**CB No: MCA-M/CF/WRA/W-01**  
**Invitation for Bids for the Wastewater Recycling Plant Design-Build**

**ANSWERS TO CLARIFICATION QUESTIONS – ISSUE No. 11 (Question 173-182)**  
**January 17, 2022**

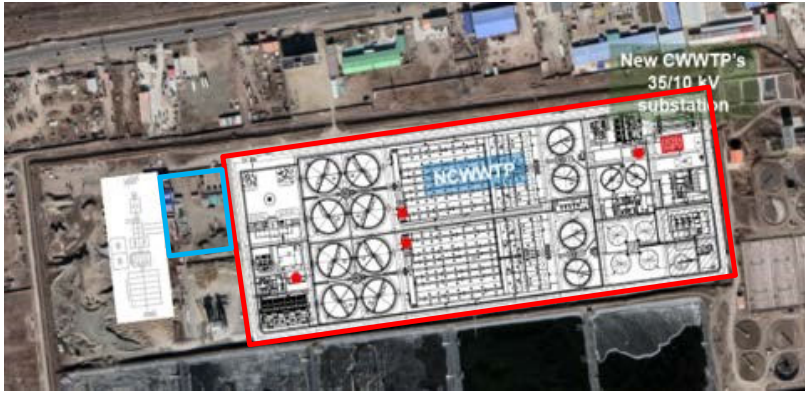
<b>Question 180:</b>	At the Employer Requirement Subclause 2.13.1.3 Fencing of Site, “The final WRP site shall be enclosed by a 2.4 m high chain-link wire security fence with an overhang, and razor wire coils.” written. But there is no information about bottom side. Please kindly provide.
<b>Answer 180:</b>	Please refer to ER’s subclause 2.13.7 / post setting material/ and subclause 2.13.9 / Chain link framework installation.
<b>Question 181:</b>	Will demolish the buildings which are seen at the existing air maps seen in the upper right corner? Please kindly clarify.

<b>Answer 181:</b>	The Bidder’s question is ambiguous. Note that buildings/facilities within the red square are part of the New Central Wastewater Treatment Plant, and do not belong to the WRP project boundary. The structure in the blue square is the campsite for the NCWWTP’s EPC contractor within a buffer zone and will not be demolished. Westside of the Blue square is the area designated for the WRP. Please see the highlighted portion of answer 182.
<b>Question 182:</b>	We lean to the right the WRP area. We understand you request to the right side regard to the Employer Requirement Subclause 2.2.1.4 Services for Site Use. Please kindly clarify
